Memo

To: Planning and Zoning Commission via Samuel Haas, Planner
From: Jennifer Shortess, P.E., Engineer
Date: December 6, 2022
Re: Recommendation for Waiver to Requirement to Construct Sidewalks and Roadway Improvements for the Core5 Development

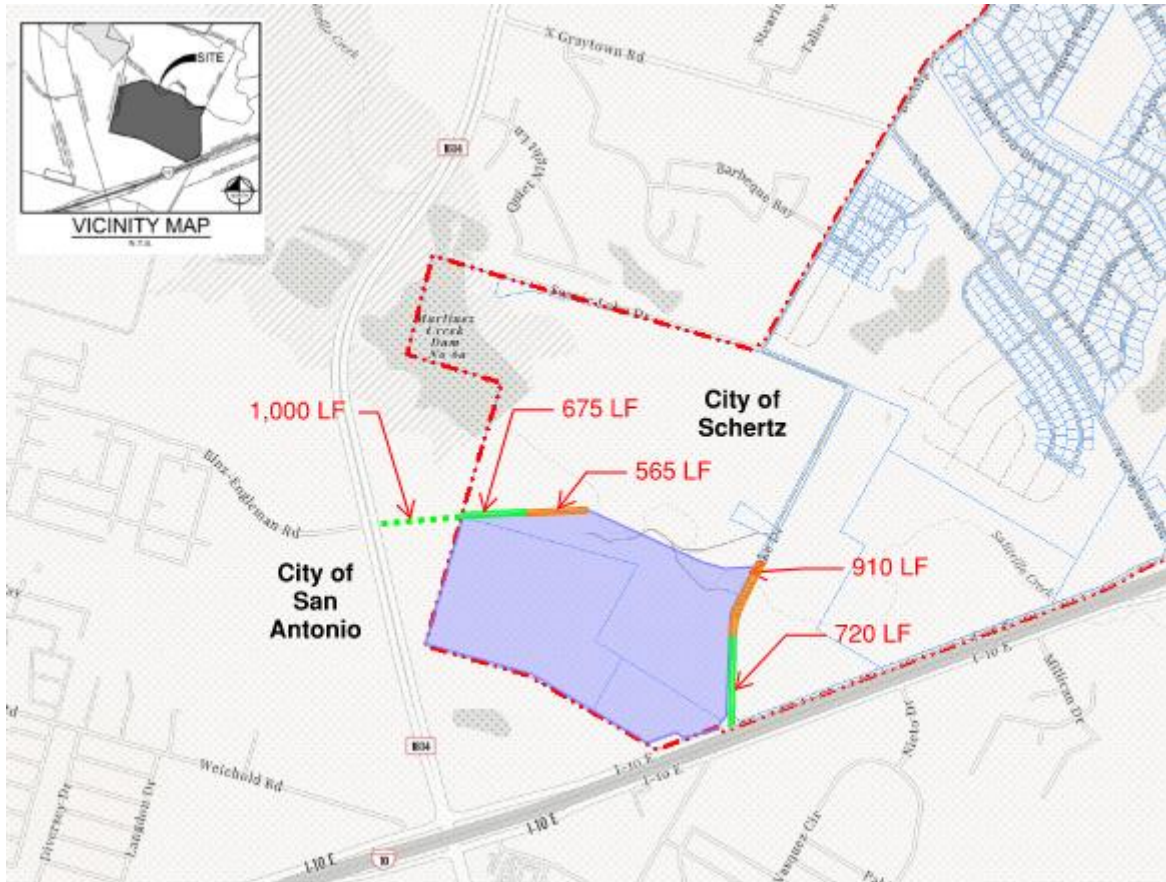
Section 21.14.1.P of the UDC requires secondary rural arterial to be constructed with 5' width sidewalks on one side and a 10' hike and bike trail on the other side of each street. Based on roadway connections outside of the City of Schertz's jurisdiction, construction of roadways and sidewalks for the full length of property frontage is not required. Therefore, in lieu of constructing roadways and sidewalks from Loop 1604 to the Core5 plat boundary (2,240 linear feet), Core5 proposes construction of roadways and sidewalks from the intersection of Loop 1604 and the Proposed Road a total distance of 1,675 linear feet.

Section 21.14.1.P of the UDC requires commercial collectors to be constructed with 5 feet width sidewalks on one side and a 10' hike and bike trail on the other side of each street. Construction of half of the roadway and sidewalk along one side of Scenic Lake Drive is required along the property

frontage (1,630 linear feet) is required. However, Core5 proposes construction of the entire roadway, sidewalk, and trail from the intersection of IH-10 access road to the Core5 driveway entrance on Scenic Lake Drive (720 linear feet).

Based on the completeness of the proposed roadway section from intersection of Loop 1604 along the Proposed Road (including sections outside of the City of Schertz), Staff has determined that the request to not construct a portion of roadways and sidewalks is reasonable and consistent with the complete streets goal on the Proposed Road. The full street section as proposed provides a greater transportation benefit than the required half street section.

Based on the completeness of the proposed roadway section at the intersection of IH-10 Access Road and Scenic Lake Drive, Staff has determined that the request to not construct a portion of roadways and sidewalks is reasonable and consistent with the complete streets goal on Scenic Lake Drive. The full street section as proposed provides a greater transportation benefit than the required half street section.

Therefore, Staff supports the applicant’s request to not comply at the time of platting with the UDC requirements to construct a portion of roadways and sidewalks to the proposed subdivision.
